## MODIFICATION

## *Service Hint*

*for C521/C541 ,C520/C540 , C522/C524*

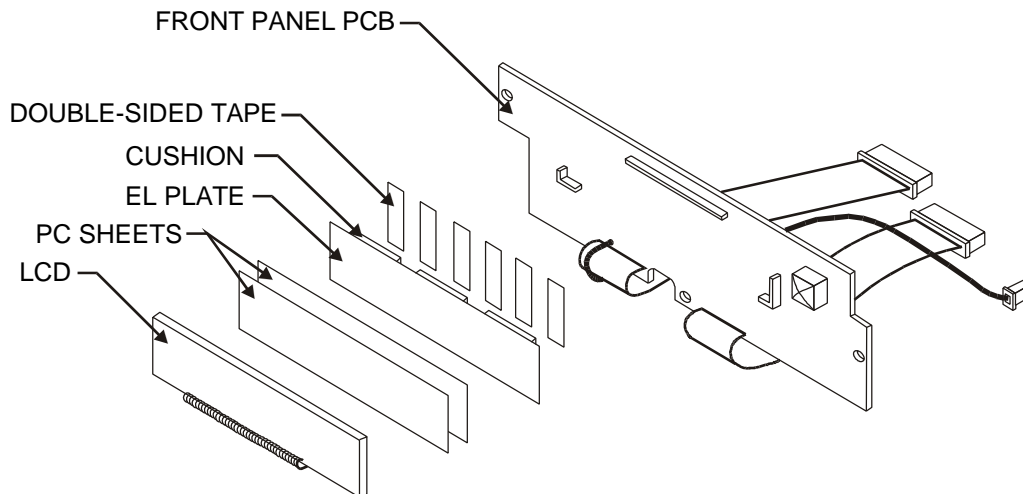
You may receive a complaint of the unit producing a very high whistle noise

The step up transformer for the display circuit is humming

1. Insert a transformer with more varnish impregnation
2. Apply glue to fix the step-up transformer to the main pcb
3. Add double sided tape between the cushion at the back of the EL display and the front panel pcb.  
Please refer to the drawing below
